**TO:** Troy Kelts, Galloway & Company  
**FROM:** Stacey Nerger, Senior Planner  
**DATE:** November 15, 2023  
**SUBJECT:** The Exchange Lot 1 – Site Plan  
Review Comments 01

# PARKER EXCHANGE BUILDING SITE DEVELOPMENT PLAN

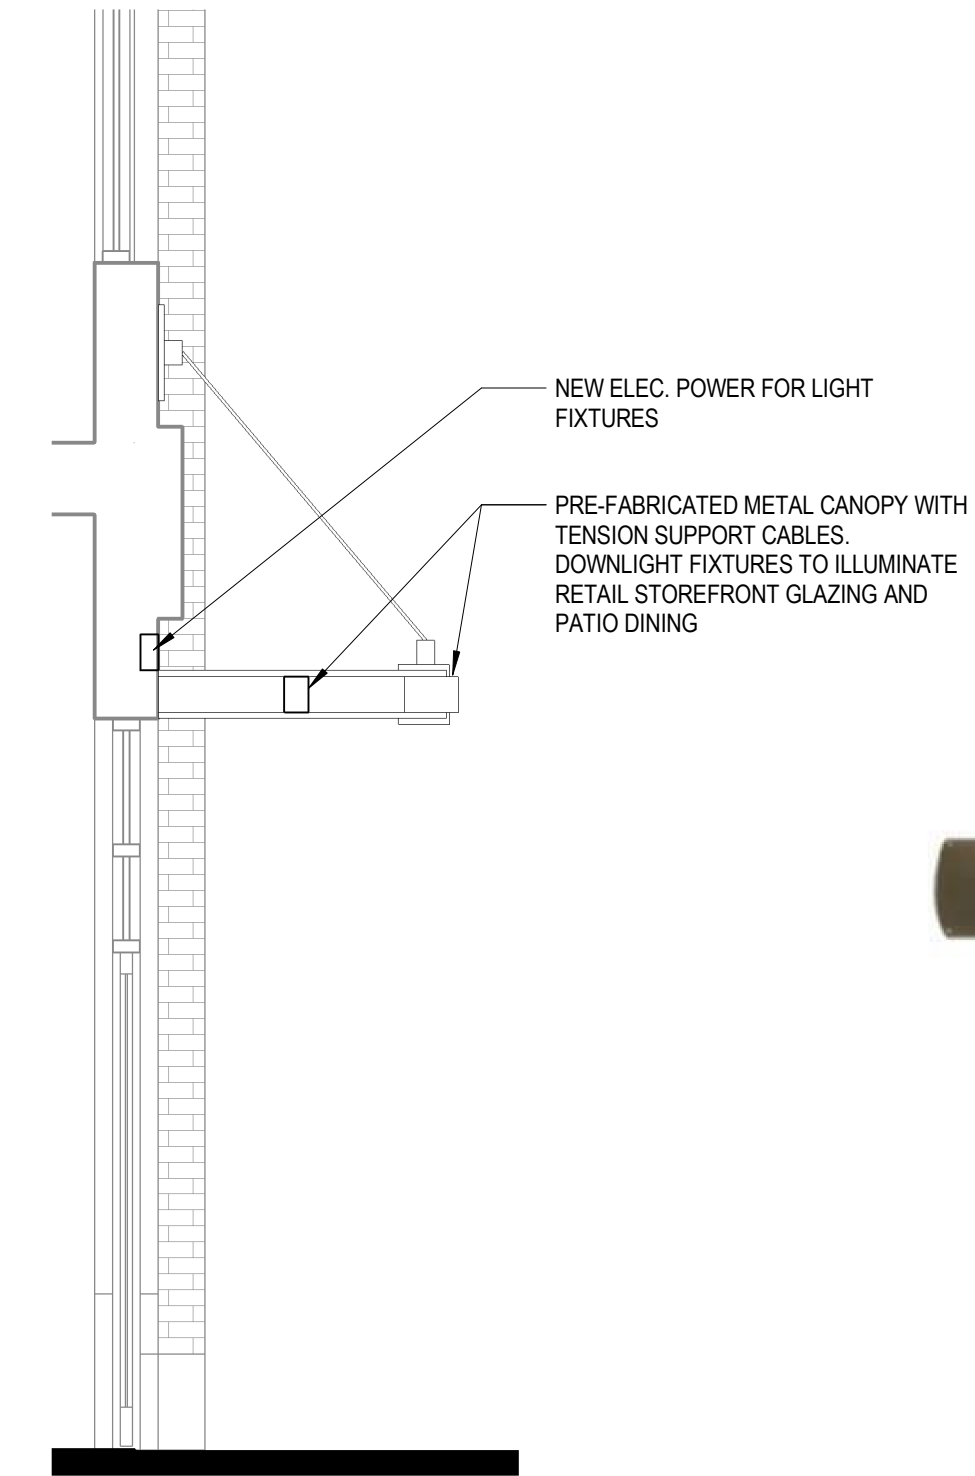
Please note signage is not approved as part of the Site Plan. Please remove all signage.

Assuming this light is attached to the wall or is this attached to the awning?

SIGNAGE DEPICTIONS  
REMOVED FROM PROJECT

LIGHT IS MOUNTED TO WALL  
BETWEEN CANOPY OPENINGS
